Sheet: /
File: FilamentMonitor.sch

Title: Filament Monitor

Rev: v2.0

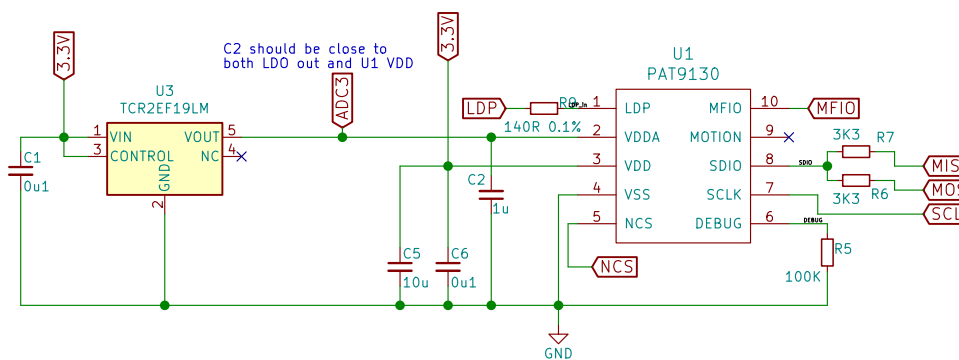
C1,C6,C5 needs to be close enough to both chips

C2 should be close to both LDO out and U1 VDD
